PSB-2005-052	Date: 15 September 2005
Title	L28 & 3400 HST; PTO "Ratcheting Noise"
Group Code	PT06
Product Line	L-series
Model Number (s)	L2800HST, L3400HST

On HST MODELS, a "Ratcheting" noise may be heard during rear PTO disengagement.

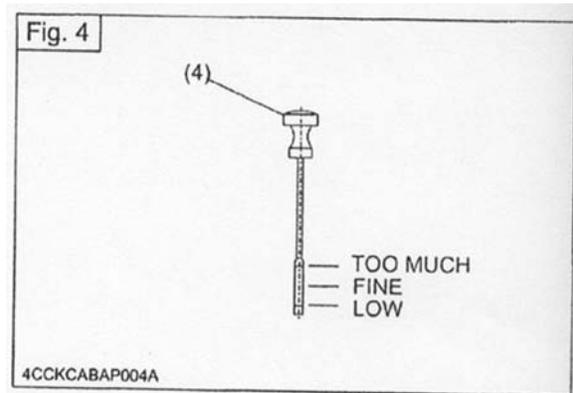
1. Remove the five bolts(B) holding the center cover(A) and remove the center cover. (fig.1)
2. Remove the drain plug(P) under the mid case(C), and drain about 3.2 quarts of transmission oil. *This will lower the oil level below the sight glass.* (fig.1)

3. Remove the oil level sight glass along with the bolt(D). (fig.1)
4. Assemble the dipstick guide(1), two o-rings* *apply grease to o-rings**(3) and the joint bolt(2) as a sub-assembly. Then install the sub-assembly into the sight glass hole of the mid-case(C). Tighten bolt(D) and torque joint bolt(2) to 36.0 – 43.0 ft-lbs.

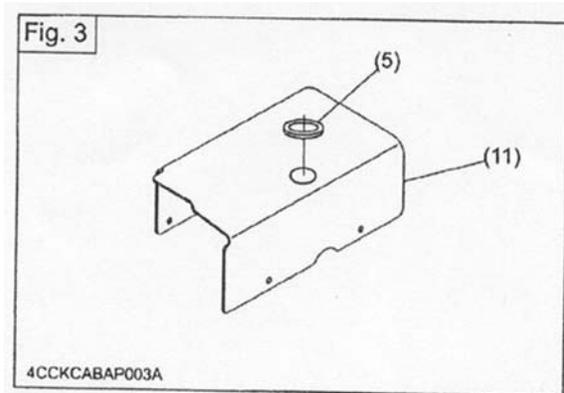
5. Remove the operator's seat & suspension(E), breather(F), pipe(G); then install the plug(6). Then re-install the seat suspension and seat. (fig.2)
6. Assemble the oil fill port extension(7), o-rings(8), oil port plug(9), and the breather(10) as a sub-assembly. Then install the sub-assembly in place of the original oil plug(H).(fig.2)

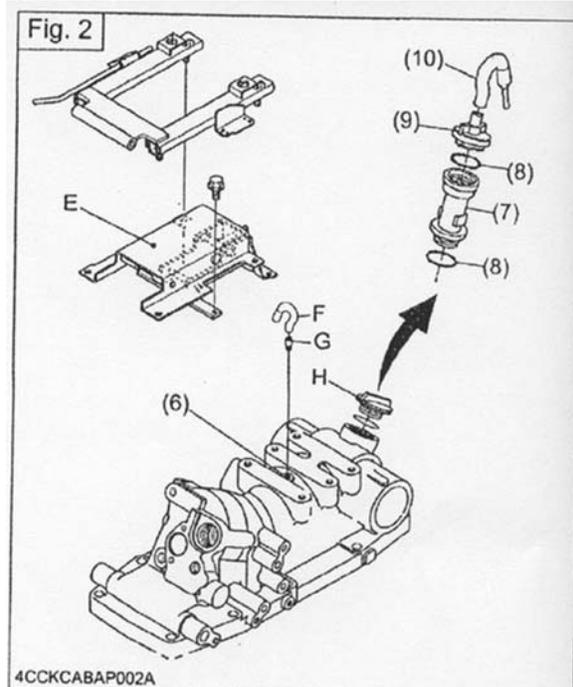
7. Insert the rubber ring(5) into the new center cover, * *has 25mm hole**(11). Install the new center cover to the mid-case(C). Tighten all five bolts(B). (fig.3)

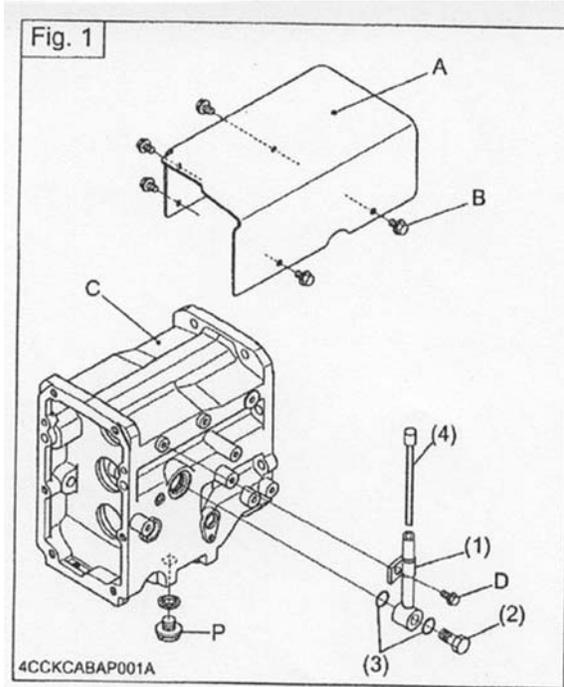
10. Check the oil level on the dipstick. Adjust oil level as necessary. (Fig.4)
